SAFETY RECALL CAMPAIGN 0105 UPDATE

ML-375

M-1119

FRONT FENDER TIP LAMP JUMPER HARNESS RETENTION

Figure 1. Left Side Front Fender Well

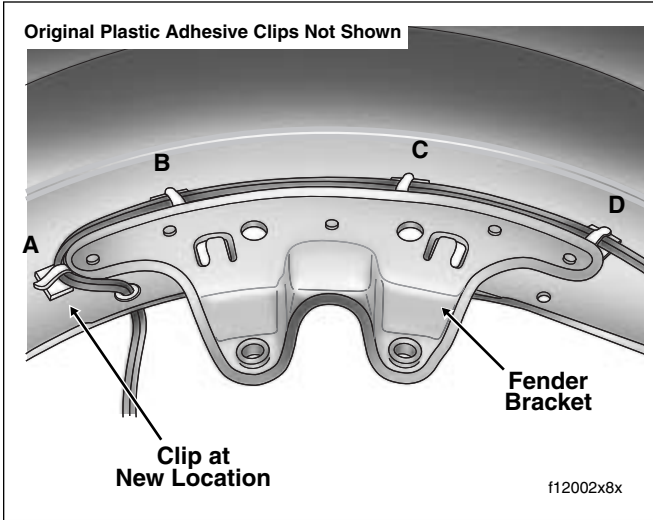
As recently advised in ML-370, Harley-Davidson has learned that the clips retaining the front fender tip lamp jumper harness can become detached on certain 2001 and 2002 FLT model motorcycles. This condition could cause the wiring to become frayed and shorted, possibly causing the lighting fuse to blow. A blown lighting fuse leaves the vehicle without an operational headlight, passing lamps, front fender tip lamp, tail lamp and running lights.

In the interest of motor vehicle safety and customer satisfaction, Harley-Davidson has elected to initiate a voluntary recall (Campaign 0105) to add four metal clips in the fender well, as well as replace the existing harness if damaged. See REQUIRED DEALER ACTION to perform the recall service.

5. Obtain Kit #93950 if no damage to the original jumper harness was observed. Obtain Kit #93951 if any damage is present.
6. Remove jumper harness, if damaged. See Section 8.14 FENDER TIP LAMPS, FRONT FENDER TIP LAMP JUMPER HARNESS, REMOVAL.
7. Install four **new** metal adhesive clips as follows:
- a. Using a soapy cleaning pad, such as Scotch Brite®, thoroughly scrub fender well at locations A, B, C and D as shown in Figure 1.

While location A is new, locations B, C and D are evenly spaced near or beside the existing plastic adhesive clips.

- b. Rinse with clear water and dry areas with a clean white cloth. Repeat step until clean cloth shows no evidence of dirt.
 - c. Swab areas with denatured alcohol.
 - d. Remove paper backing to expose adhesive and firmly press clips into place.
8. If any damage to the original jumper harness was observed, install **new** harness from Kit #93951. See Section 8.14 FENDER TIP LAMPS, FRONT FENDER TIP LAMP JUMPER HARNESS, INSTALLATION.
9. Route the wires of the jumper harness through the four new metal adhesive clips added in step 7.
10. Verify that jumper harness is now properly routed through one weld clip, four new metal adhesive clips, and as many as three original plastic adhesive clips.

11. Verify that no portion of the jumper harness crosses over the riveted fender bracket.

12. Using finger pressure, bend arm of each clip down over wires so that no portion of the clip is above the height of the fender bracket.
13. Install front wheel. See Section 2.2 FRONT WHEEL, INSTALLATION.
14. Insert bolt through battery negative cable (black) into threaded hole of battery negative (-) terminal. Tighten bolt to 60-96 **in-lbs** (6.8-10.9 Nm).
15. Install seat. See Section 2.21 SEAT, INSTALLATION.
